Office Action Summary	Application No. 10/562,963	Applicant(s) HODGSON, JAMES MATHEW	
	Examiner MELISSA L. LALLI	Art Unit 3728

DETAILED ACTION

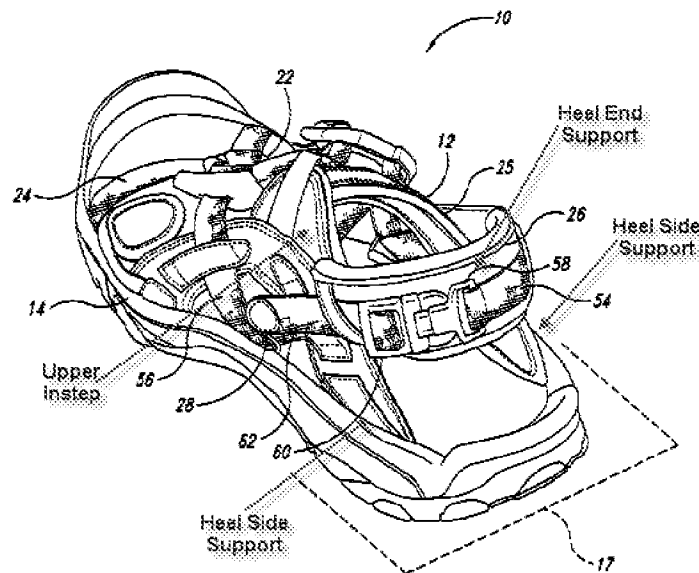
8. Claims 34-39, 41, and 42 are rejected under 35 U.S.C. 102(e) as being anticipated by each of Bathum and Matis.

Regarding claims 34-37, Bathum and Matis each disclose an article of footwear (10; 40) comprising: a sole (16; 42) having a toe part (33; at 66), a ball part (40; fig. 5, at 42), an instep part (38; fig. 5, at 80), and a heel part (17; fig. 5, at 64); an open toe section (figs. 1, 2, & 8; figs. 4-6); an instep section (12; 48) having two instep side supports (fig. 8, at 28 and not shown opposite; fig. 7, sections of 128 which attach to slots 74 & 48), the instep side supports being connected to the instep part of the sole

and otherwise being open (figs. 1 & 8; figs. 4-6); and a heel section (26; fig. 7, at 128), wherein the heel section has two heel side supports and an end heel support (see annotated fig. below; fig. 7, sections of 128 which attach to slots 72 & 76 and section of 128 at 128), and the two heel side supports and the end heel support are connected at a first end to the heel part of the sole and are connected to each other at the other end (fig. 8; figs. 4-7).

Regarding claims 38, 39, 41, and 42, Bathum and Matis each disclose an upper instep section (see annotated fig. below; fig. 7, 120, 122, & 130). The upper is attached to the instep side supports by means of adjustable ties (18 and 24-26; 44). One or more straps (24; fig. 7, 100, 102a, & 102b) are attached to an upperside of the toe part (fig. 1; figs. 4-7). The article of footwear (10; 40) is an athletic shoe (col. 1, lines 43-48; figs. 4-7).
